EAST RENFREWSHIRE COUNCILLOCAL REVIEW BODY7 November 2018Report by Deputy Chief ExecutiveREVIEW OF CASE - REVIEW/2018/21FORMATION OF DRIVEWAY INCORPORATING REDUCTION IN GROUND LEVELS
AND ERECTION OF BOUNDARY WALL AT 29 EAST KILBRIDE ROAD, BUSBY**PURPOSE OF REPORT**

2. Application type: Full Planning Permission (Ref No:- 2018/0385/TP).
- Applicant: Mr Paolo Di Mambro.
- Proposal: Formation of driveway incorporating reduction in ground levels and erection of boundary wall.
- Location: 29 East Kilbride Road, Busby.
- Council Area/Ward: Clarkston, Netherlee and Williamwood (Ward 4).

**Visibility Splays for plot 29 East
 Kilbride Road**
 Scale 1:200 @ A1

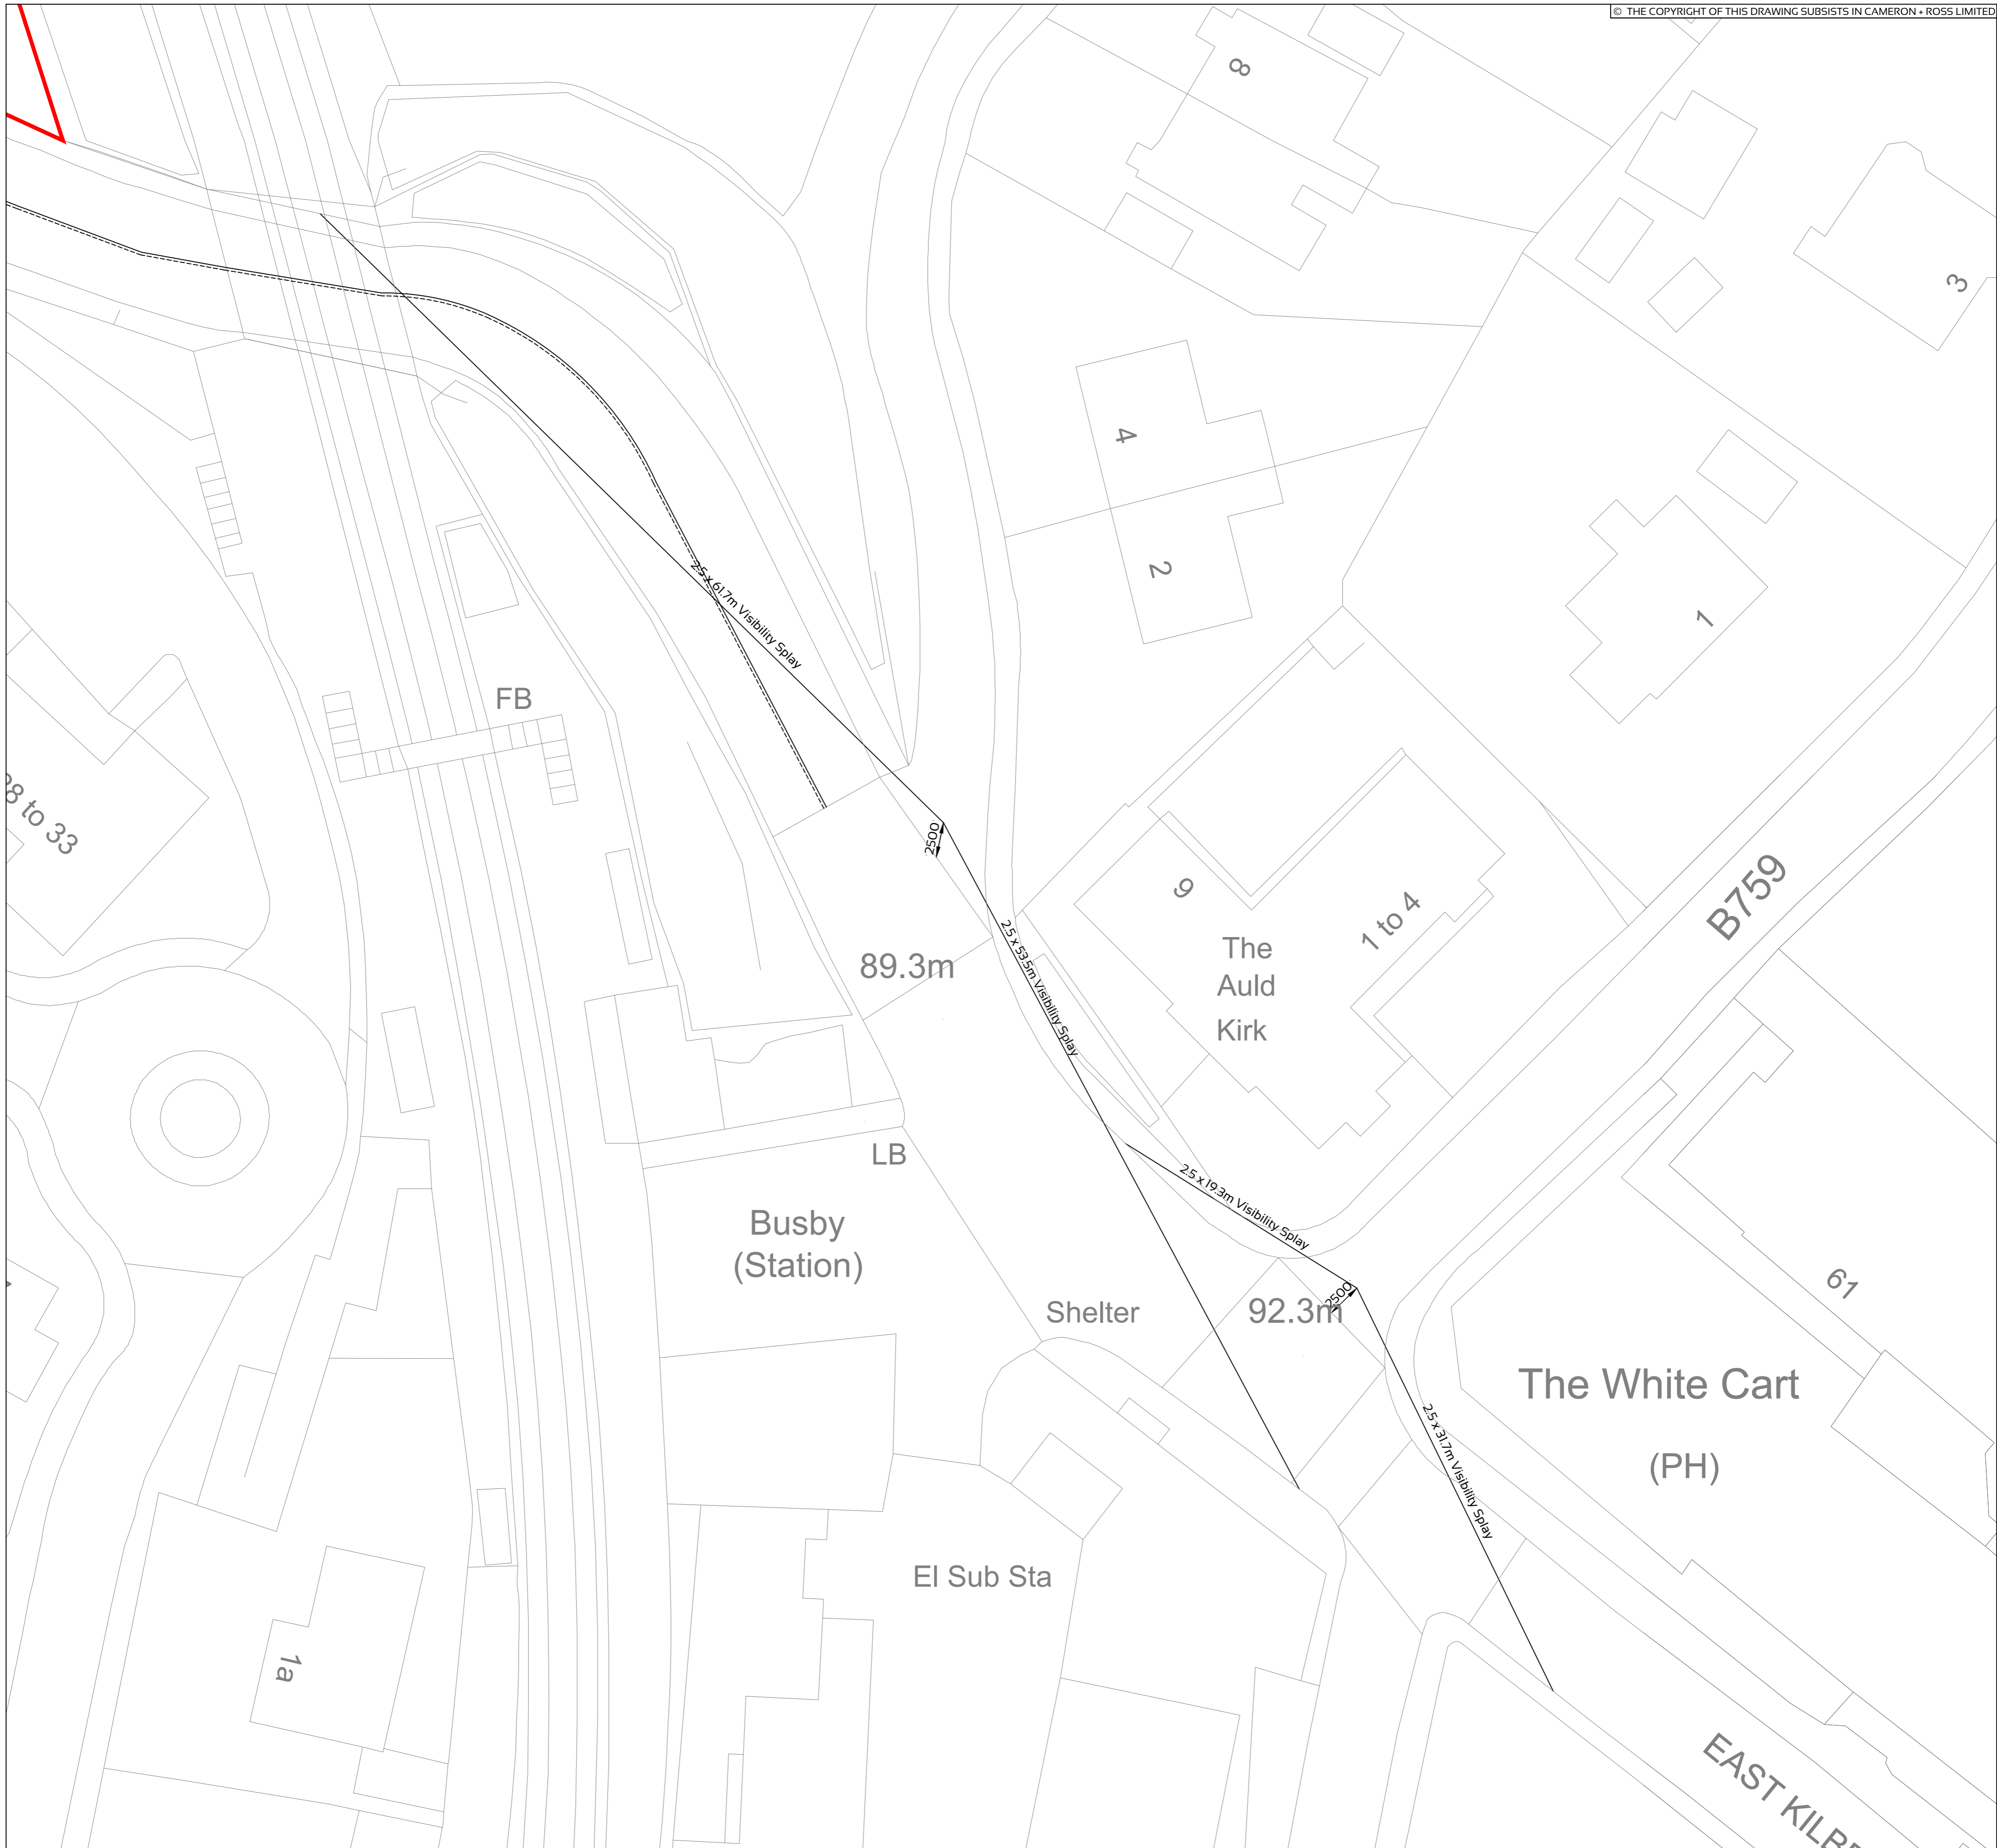
The required visibility for a 30mph road is 2.5m x 90m in both the primary and secondary directions with no interference allowed within the splay above a height of 1.05m. This can clearly not be achieved at the location being proposed for the new access. This is shown within Drawing 903, Rev I where the visibility in the primary direction is significantly less than required. It should be noted that the visibility splays here should be measured to the edge of the nearside carriageway.
